**Well Name:** BIG EDDY UNIT 30E  
SKYWALKER

**Well Number:** 100H

**Type of Action:** APD Change

**Procedure Description:** XTO Permian Operating, LLC. is requesting corrected COAs based on conversation with Allison Morency. \*\*Casing & Cement Change XTO Permian Operating, LLC requests permission to make the following changes to the original APD: Casing and cement changes due to US supply chain issues. Updated drilling program is attached. Attachments: Drilling Program MBS Diagram

20" x 9-5/8" x 7-5/8" x 5-1/2" MBU-T-CFL-R-DBLO Wellhead  
 With 1 1/2" 10M x 7-1/16" 15M CTH-DBLHPS Tubing Head  
 And 9-5/8", 7-5/8" & 5-1/2" Pin Bottom Mandrel Casing Hangers

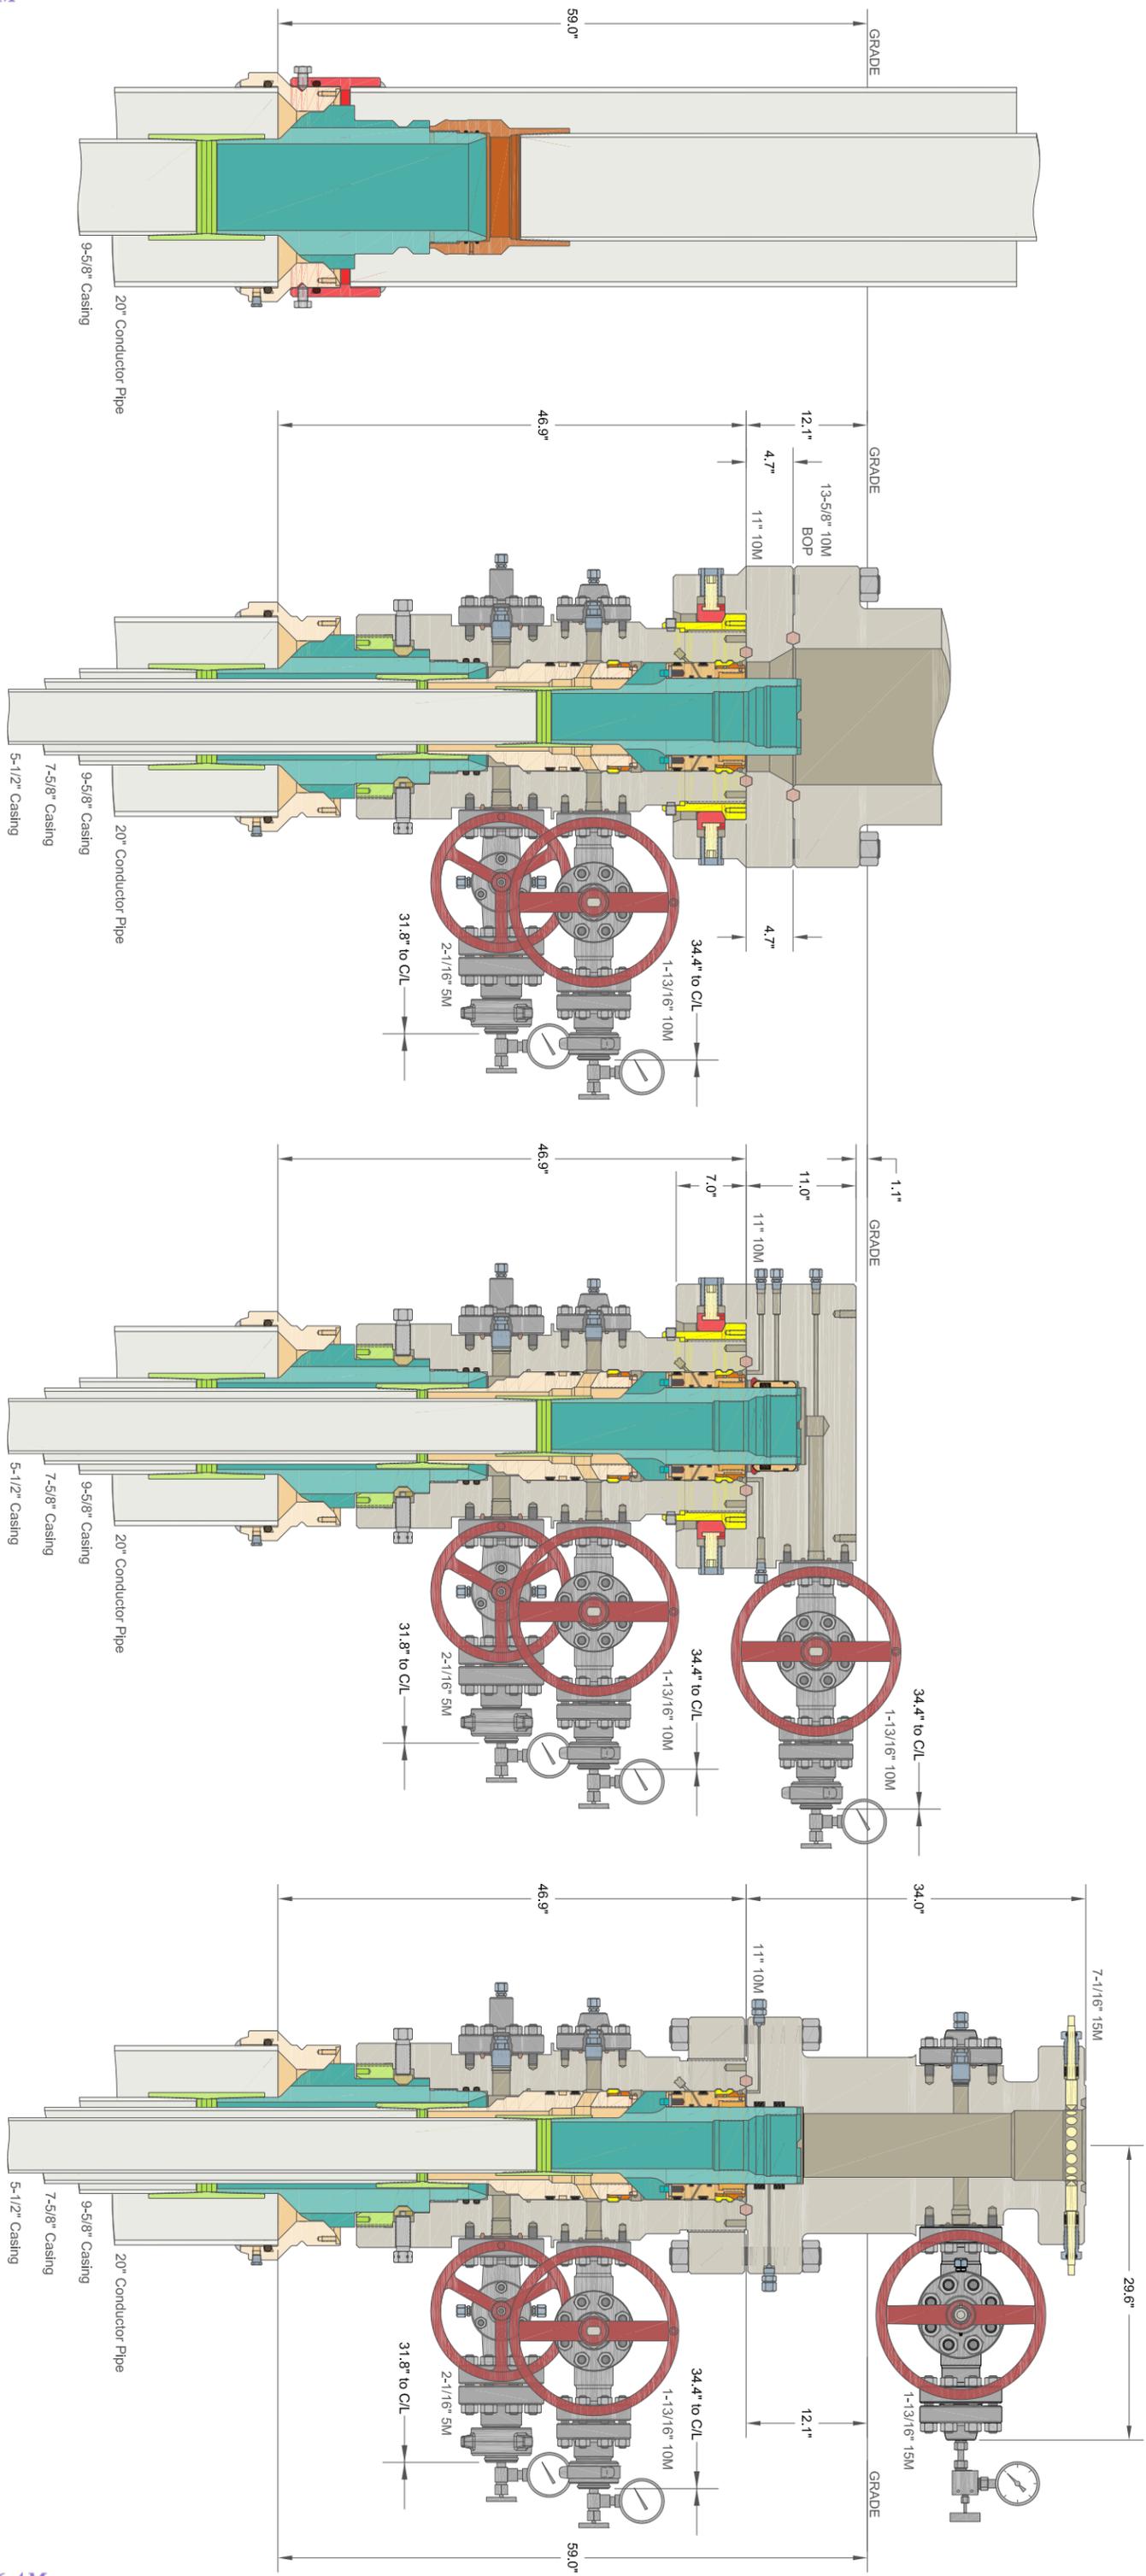
Permanent Wellhead – Multibowl System

A. Starting Head: 13-5/8" 10M top flange x 13-3/8" bottom

B. Tubing Head: 13-5/8" 10M bottom flange x 7-1/16" 15M top flange

- Wellhead will be installed by manufacturer's representatives.
- Manufacturer will monitor welding process to ensure appropriate temperature of seal.
- Operator will test the 9-5/8" casing per BLM Onshore Order 2
- Wellhead Manufacturer representative will not be present for BOP test plug installation

2. Operator has proposed a multi-bowl wellhead assembly. This assembly will only be tested when installed on the surface casing. Minimum working pressure of the blowout preventer (BOP) and related equipment (BOPE) required for drilling below the surface casing shoe shall be **2000 (2M) psi**.

- a. Wellhead shall be installed by manufacturer's representatives, submit documentation with subsequent sundry.
  - b. If the welding is performed by a third party, the manufacturer's representative shall monitor the temperature to verify that it does not exceed the maximum temperature of the seal.

- c. Manufacturer representative shall install the test plug for the initial BOP test.
  - d. If the cement does not circulate and one inch operations would have been possible with a standard wellhead, the well head shall be cut off, cementing operations performed and another wellhead installed.
